CONTINENTAL MOTORS® AIRCRAFT ENGINE
SERVICE INFORMATION LETTER

CATEGORY 5
SIL14-4B

Supersedes SIL14-4A
TECHNICAL PORTIONS
FAA APPROVED

SUBJECT: 24 Volt/70 Amp Belt-Driven Alternator Brace Alignment

Figure 1. Bracket Assembly Inspection Area

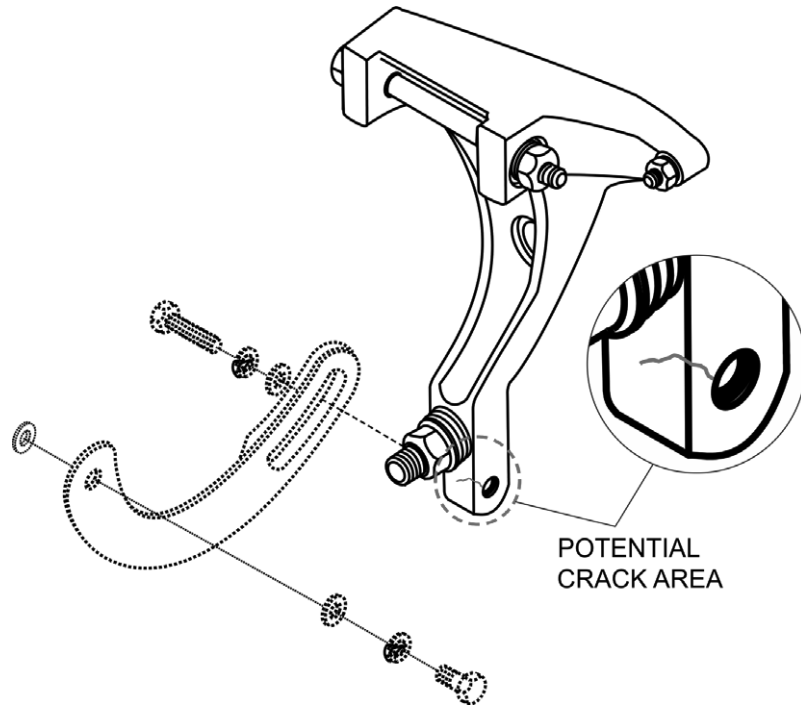
3. Perform a visual inspection using a minimum 10x magnifier and bright light source on the cast aluminum bracket to verify the area surrounding the mounting boss and helical coil insert is not cracked (see Figure 1, "Bracket Assembly Inspection Area," on page 2).

- a. If the components are serviceable, install the belt-driven alternator according to the instructions in Section IV, "Bracket Assembly Installation," on page 2.

- b. If any of the removed components exhibit physical damage or the 10x visual inspection indicates the bracket assembly is cracked, obtain the necessary replacement parts and install according to the instructions in Section IV, "Bracket Assembly Installation," on page 2.

Figure 2. 70 Amp Belt-driven Alternator Assembly

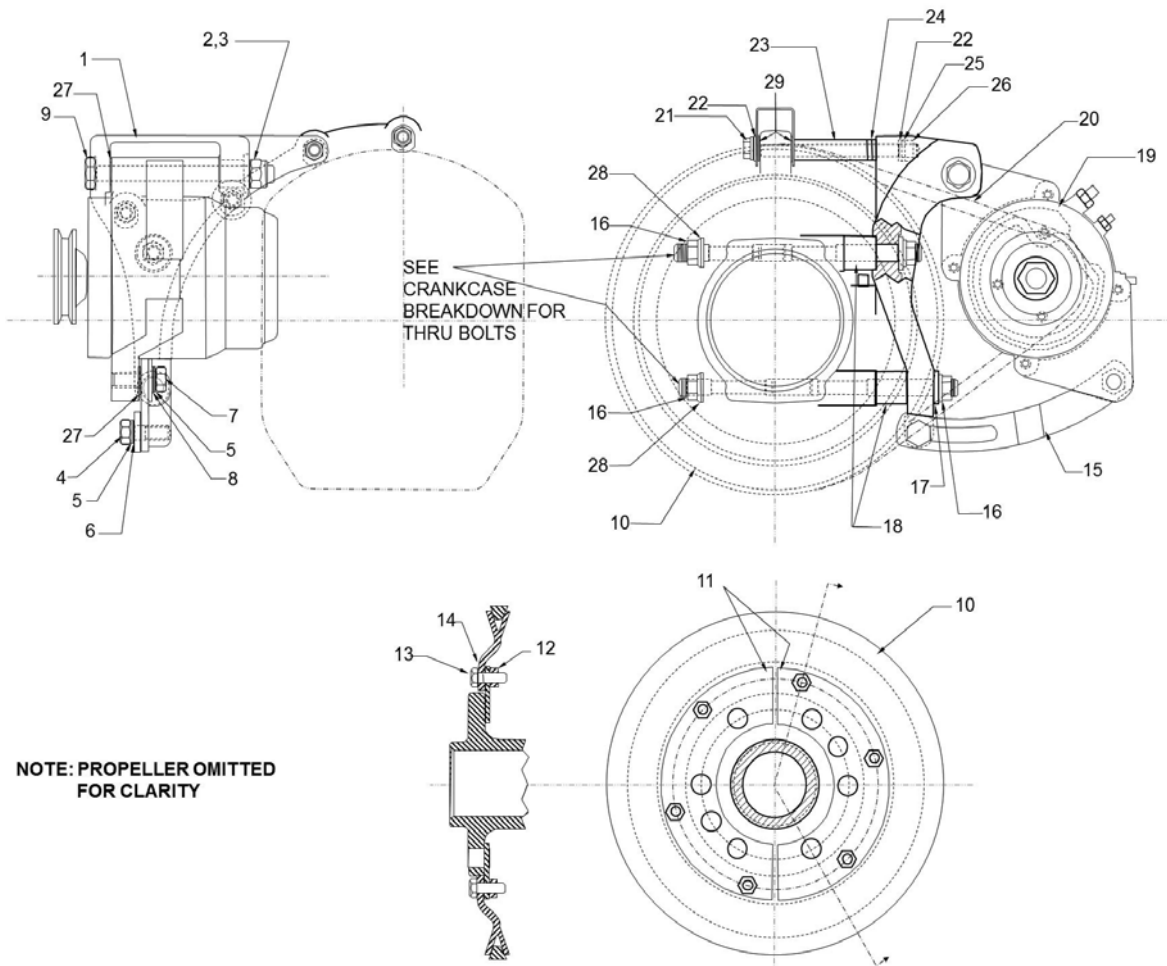
1. Install the propeller according to the propeller manufacturer's instructions.
2. Align the holes on the drive sheave (Figure 2, item 10) with the propeller flange holes.
3. Align the split sheave adapters' (11) bolt holes with those in the drive sheave (10).

4. Install six bolts (13) with washers (14) through the front of the drive sheave (10) and split sheave adapter (11) bolt holes. Install a lock nut (12) on each of the six bolts (13); torque the fasteners to 90-100 in. lbs.
5. Install the bracket assembly (1) on the 2-4-6 side of the crankcase with the following hardware:
 - a. Add spacers (18) to the exposed ends of the 2-4-6 crankcase through-bolts at the propeller flange. Secure the bracket to the through-bolts with washers (17) and nuts (16). Do not torque the bracket fasteners at this time.
 - b. If a standard length bolt was installed in crankcase backbone position #3 during crankcase assembly, remove and discard the bolt.

CAUTION: Inserting an incorrect combination of shims (Figure 2, item 24) at the upper mounting location may hinder the proper alignment of the bracket to the engine crankshaft.

Figure 3. Bracket Shims

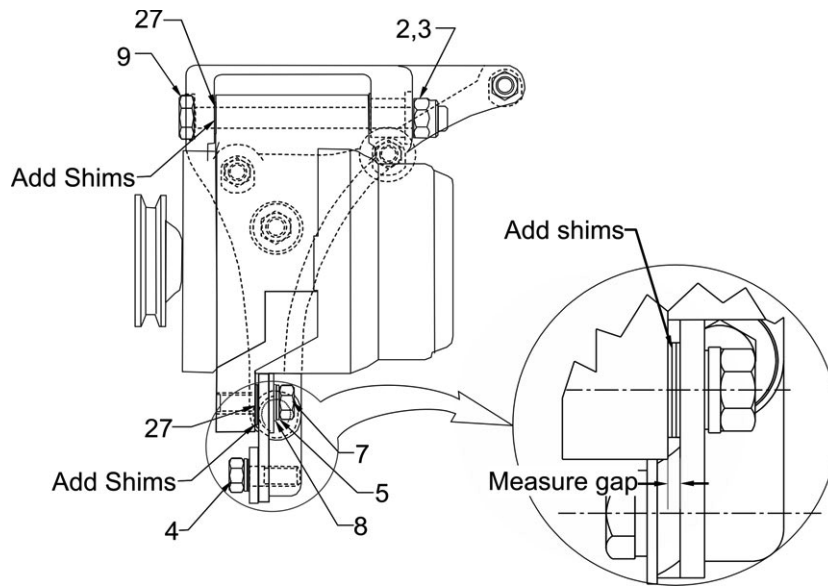
- b. If misalignment is greater than 0.016 inch, the alternator is not properly aligned. Align the two sheaves by first removing the lock nut (3) and washer (2) from the bolt (9) and insert shims (27) between the forward boss of the mounting bracket (1) and the upper alternator assembly (19) mounting (see Figure 3, “Bracket Shims,” on page 5). Secure the bolt (9) and torque the nut (3) to 250 in. lbs. to seat the alternator bracket bushing then back-off the nut (3) one full-turn counter-clockwise.

CAUTION: No gap is permitted between the alternator brace and the mounting boss. If the gap is between 0.001” and 0.031”, add a shim to fill the void.

12. Loosen the pivot bolt (Figure 3, item 4) and insert shims (27) to completely fill the gap between the brace and the outboard alternator mounting boss. Install adjustment bolt (7), new lock washer (5), and washer (8) through the shims (27) and adjustable brace (15) and into the threaded outboard alternator mounting boss.
